West Winch Housing Access Road

Chapter 11: Water Management – Appendix M: LLFA Correspondence

Document Reference: NCC/3.11.01M

Pre-Application Advice: West Winch Housing Access Road (WWHAR)

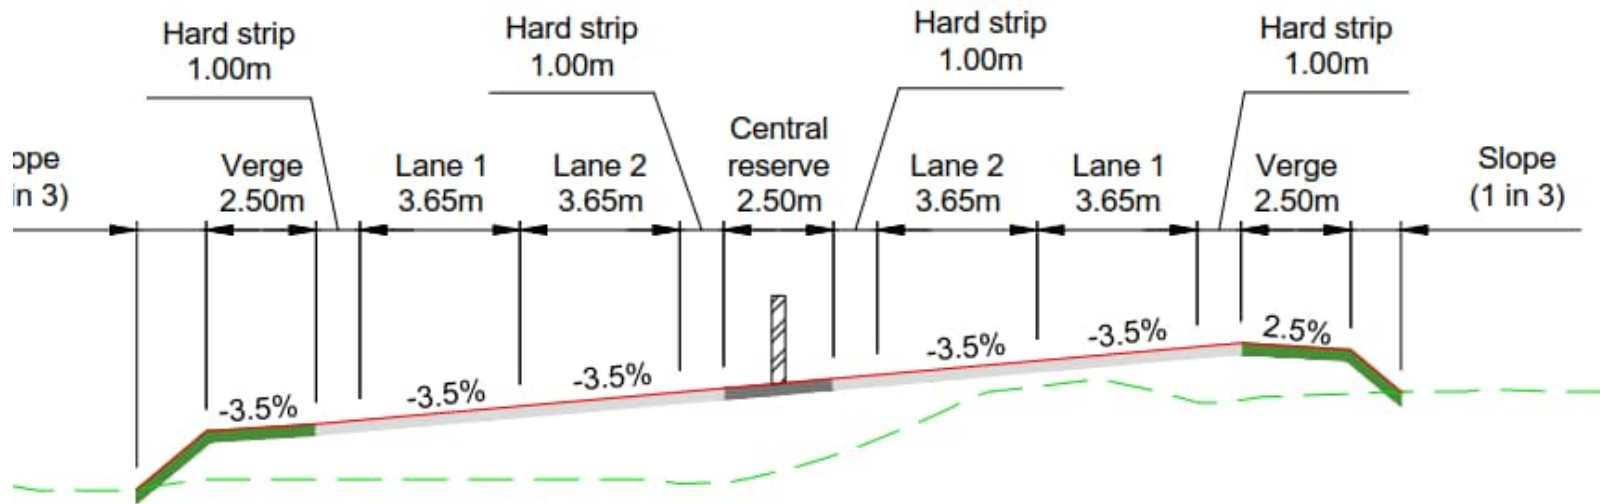
- National Highways (NH) will not accept any verges in the central reserve given the associated H&S maintenance risks for operatives, therefore it will not be possible to provide any filter strips in this part of the highway cross section. **Noted**

- The proposed A47 verge widths are 2.5m as this would enable a DMRB-compliant drainage system (grassed SW channels/filter drains) to be provided. **Noted** If we were to provide 2.5m wide filter strips as well as providing a filter drain in the verges, the verges would need to be widened significantly. **How wide?** We discussed this wider verge option with National Highways at a meeting yesterday and they expressed a strong preference against it due to additional maintenance requirements associated with wider verges and also flagged safety concerns relating to the increased likelihood of vehicles parking on the enlarged verges and using them as informal laybys. In light of these comments, would you accept the 2.5m wide verges (to include a filter drain + varying width filter strip dependant on filter drain size)? **As this is trunk road and all lanes hung to the west, it will be generate high pollutants and has highest pollution indices. As an alternative i propose you use a typical swale or grass SW channel which have slightly better treatment indices rather than filter drains, which then allows for a slightly reduced filter strip width. Maybe 2m say. It depends on the HEWRAT assessment says also.**
